# Notice of Meeting for the Historic and Architectural Review Commission of the City of Georgetown August 13, 2020 at 6:00 PM at Teleconference

Meeting Date: *August 13, 2020* File Number: *2020-34-COA*

Project Name: 1610 S. Church Street Garage

# **Proposed Addition - Plan**

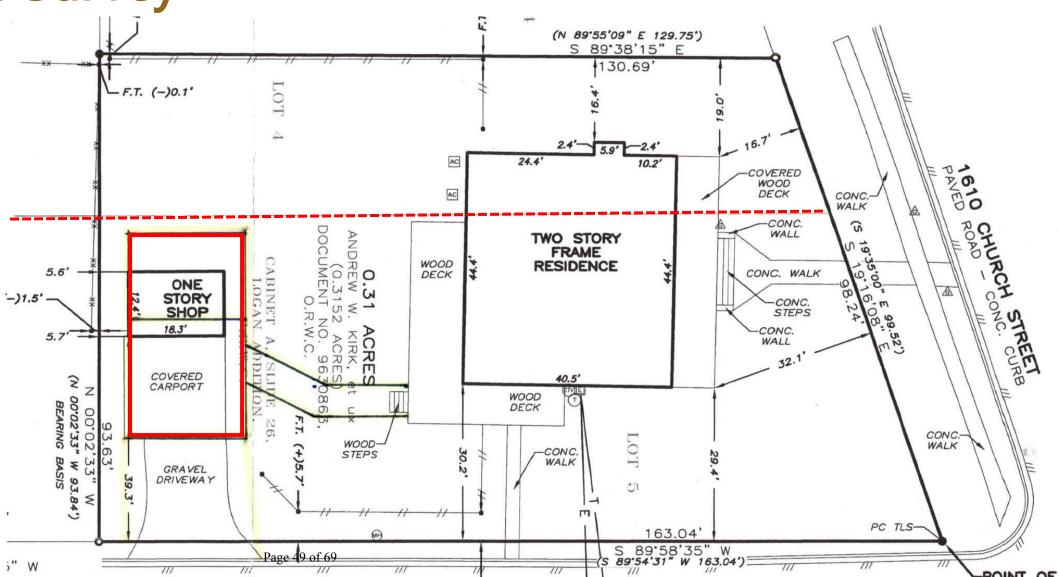
The addition is proposed to be in the same location as the original and current garage/shed/carport, which requires setback modifications for the street facing garage, side street and rear setbacks due to the current setback requirements for the Residential Single-Family zoning district. The third setback modification required for the proposed project, the 2'-9" setback encroachment into the required 6' side (north) setback for Lot 5 to allow a residential structure 3'-3" from the lot line, is due to the location of a lot line within the property boundary. When the Shermans had the house built, they owned Lot 5 and part of Lot 4 of the Logan Addition, which gave them a larger yard or property than they would have with just a single lot. At the time buildings were constructed across lot lines, and there were no setbacks since zoning had not been established as a city power. Today, the City of Georgetown Unified Development Code applies setbacks to lot lines, even when those lot lines are within current property ownership boundaries, which is why this setback modification is part of the project request. This interior setback modification also reduces the setback modification needed for the street-facing carport.

The Unified Development Code also requires a building height of 15' at the required setbacks within the Old Town Overlay District, and the proposed height of the second floor of the addition – which is measured as the average of the ridge and eave height – at the rear property line setback is 23' and requires an 8' building height modification.

Based on the findings listed above, staff recommends *APPROVAL* of the request for the addition, 5′-4″ setback encroachment into the required 25′ street-facing garage setback to allow a residential structure 19′-8″ from the side street (south) property line, 2′-9″ setback encroachment into the required 6′ side (north) setback for Lot 5 to allow a residential structure 3′-3″ from the lot line, and 8′-0″ building height modification to the required 15′ maximum building height at the rear (west) setback, to allow a building height of 23′-0″ at the rear (west) setback; and DENIAL of the request for a 4′-6″ setback encroachment into the required 10′ rear (west) setback, to allow a residential structure 5′-6″ from the rear (west) property line. Requiring the addition to be constructed without the rear setback encroachment would move the addition 4′-6″ closer to the main structure, reducing the length of the breezeway and still sufficiently distanced from the large tree in the City's right-of-way. It would also reduce the needed building height modification from 8′-0″ to 5′-0″ at the rear setback.

# Proposed Addition – South & East Elevations

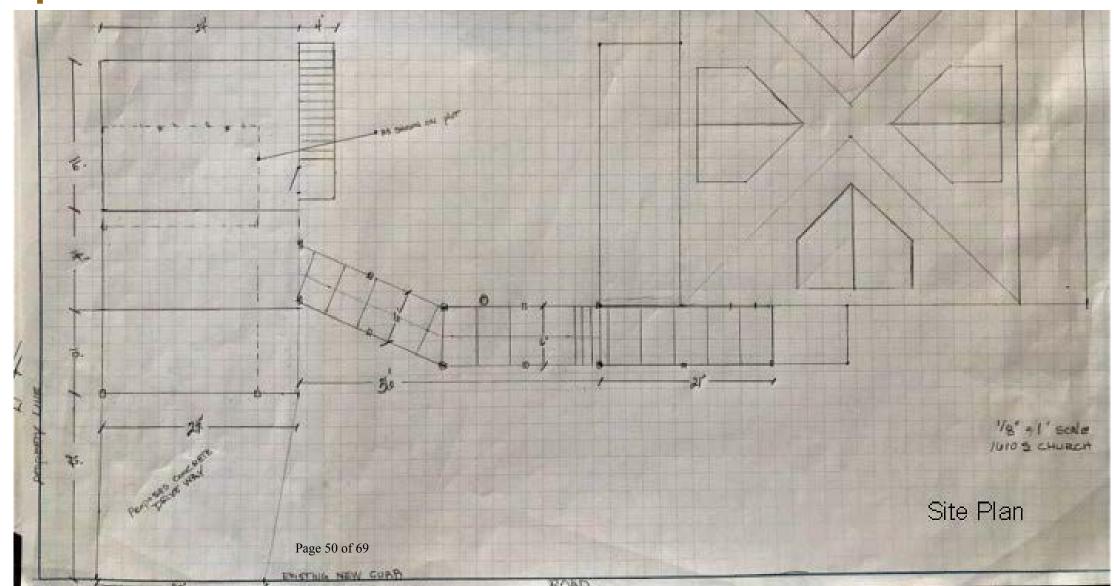
14.16 An addition shall be compatible in scale,	Partially Complies	
materials, character, and architectural style with the	Proposed addition is compatible with the	
<ul> <li>main building.</li> <li>✓ An addition shall relate to the historic building in mass, scale, and form. It should be designed to remain subordinate to the main structure.</li> <li>✓ While a smaller addition is visually preferable, if a residential addition would be significantly</li> </ul>	main building, simple in design and sets the second floor back from the front of the carport to reduce the height along the street façade of the structure. Additionally, is it connected to the main structure via a linking structure. However, the link is via	
larger than the original building, one option is	an approximately 36' long breezeway
